| Project | IEEE 802.16e Broadband Wireless Access Working Group < <u>http://ieee802.org/16</u> > |
| Title | Clarification on Figure 70a and Figure 70b |
| Abstract | This document clarifies the meaning of * symbol into Figure 70a and Figure 70b and specifies that figure 70b is MS related |

Figure 70a – Network entry state-machine BS side.

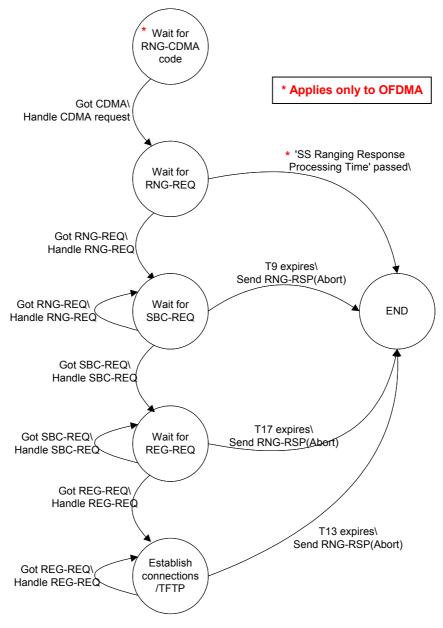
Due to some mistake during previous presentations the sentence "* Apply to OFDMA only" has been

moved closed to the name of the figures, so it seems that figures apply to OFDMA only. Because the figure are valid both for OFDM and OFDMA the sentence "* Apply to OFDMA only" has to be moved away from the name of the figure in order to remove ambiguities.

The sentence "* Apply to OFDMA only" means that the specific transition into the diagram applies to OFDMA only.
